Project
**COCKAYNES LANE
ALRESFORD**

Title
MANAGED AREAS PLAN

Scale 1:1250 @ A2	Date OCTOBER 2017	
Dwg.no 97053000	Sheet 1 of 1	Rev.no N

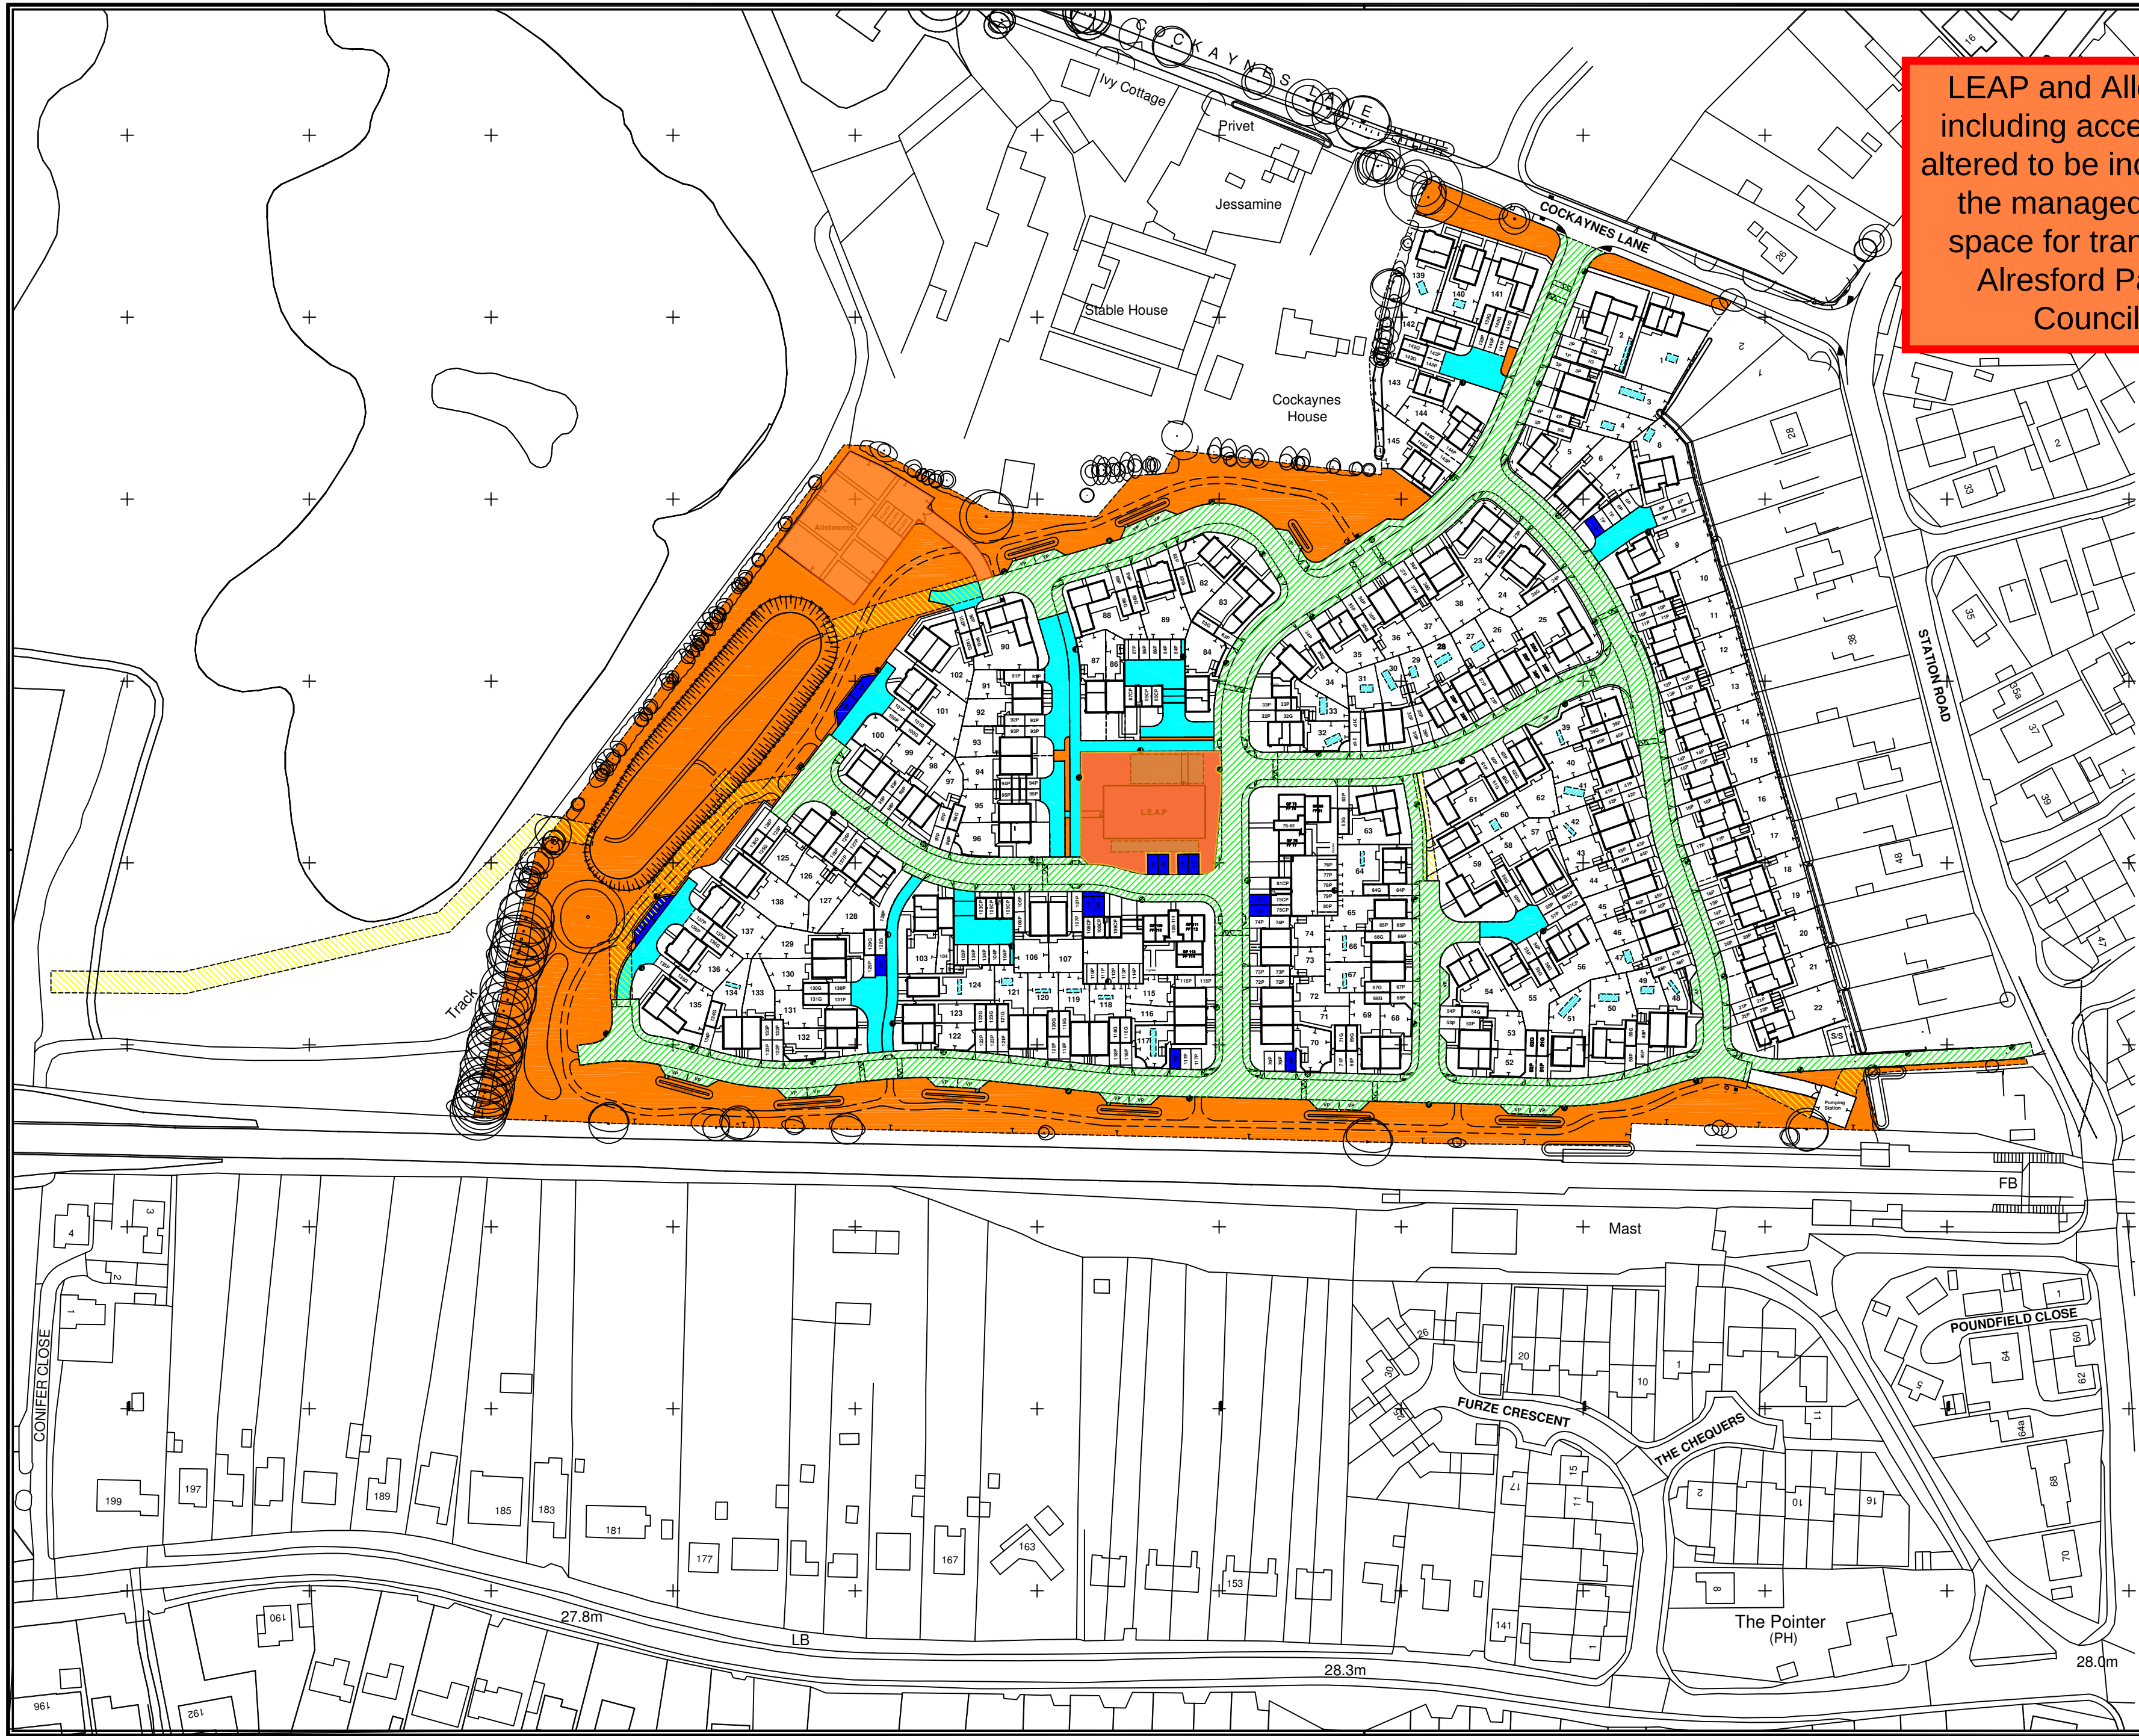
LEAP and Allotment including access way altered to be included in the managed open space for transfer to Alresford Parish Council.
